**Amendments to the Drawings:**

S/N: 10/635,344  
Reply to Office Action of April 18, 2005

Title: HOLLOW CATHODE SPUTTERING APPARATUS AND RELATED METHOD  
First Named Inventor: Alan E. Delahoy  
Application Serial No.: / Atty. Docket No.: ENPI 0101 PUS

Figure 7

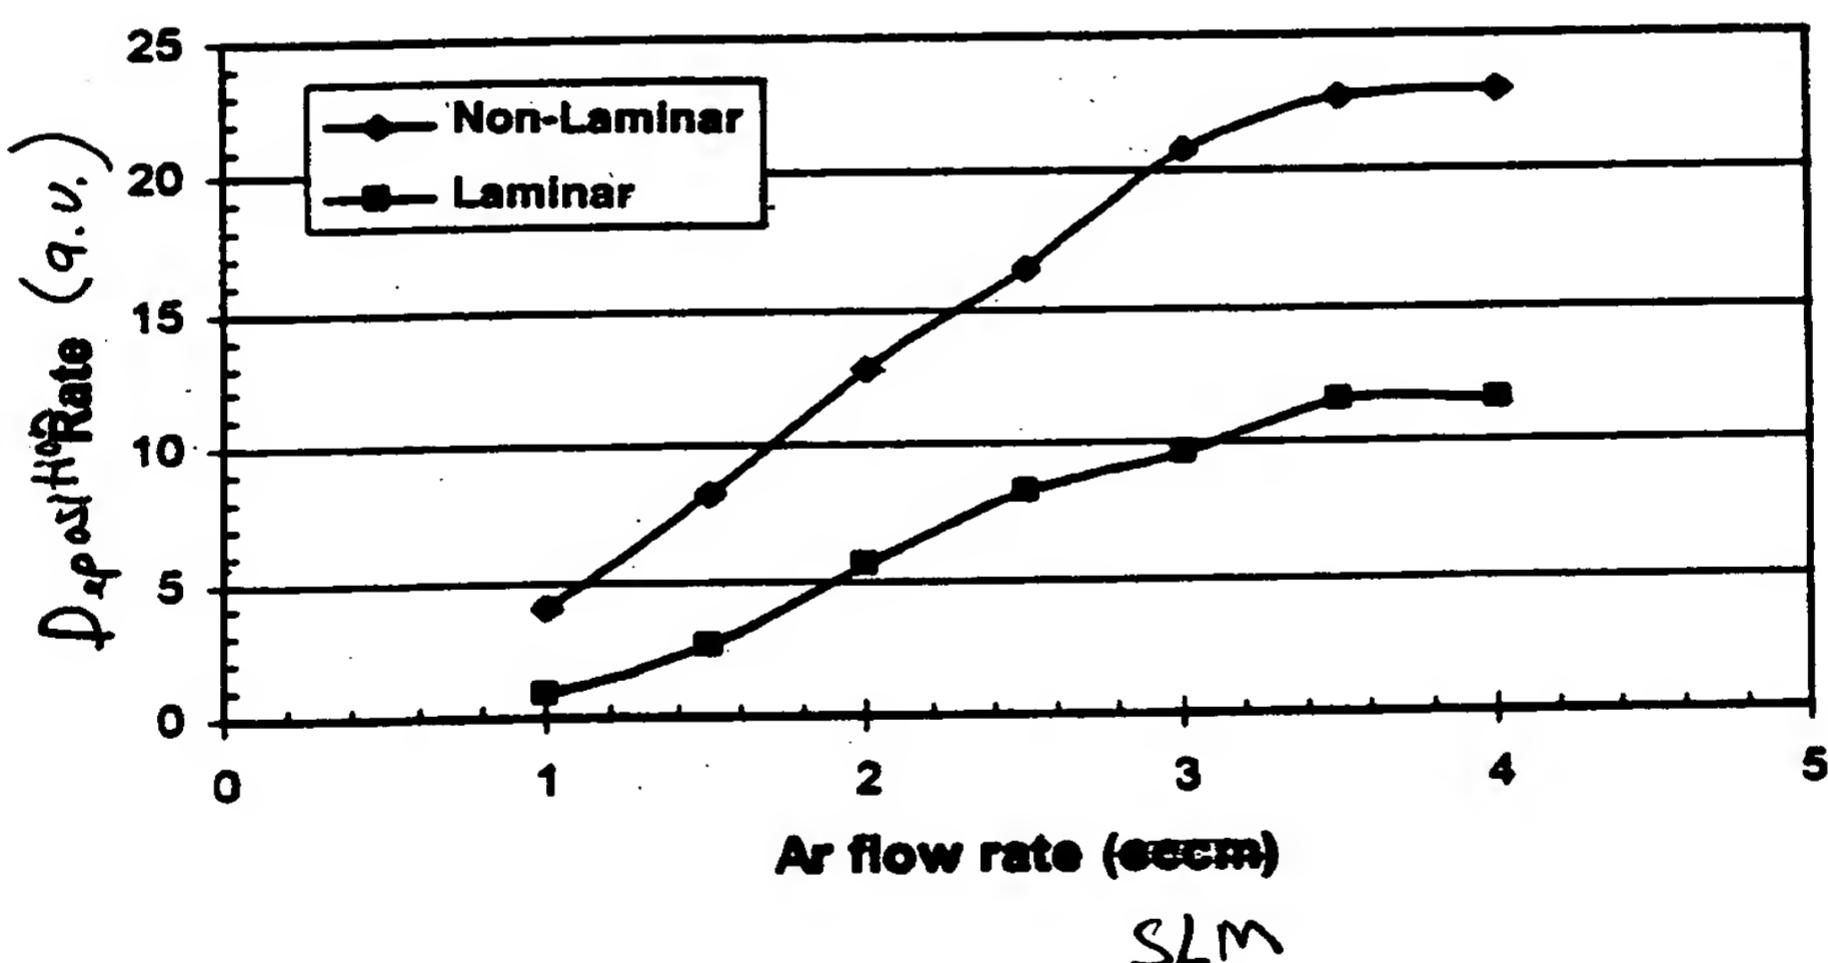
Figure 7 is amended to correct two obvious errors. The units of the x-axis are corrected to be "slm." This is clear from the other examples and Figures in the Specification. In particular, the Examiner is directed to Example 6 in which zinc oxide is grown with only a small amount of dopant. Moreover, one skilled in the art would know that the units must be slm as units of sccm would give vanishing low film growth. Figure 7 is further amended to indicate that the units are "a.u." This again, obvious from the other examples and figures.
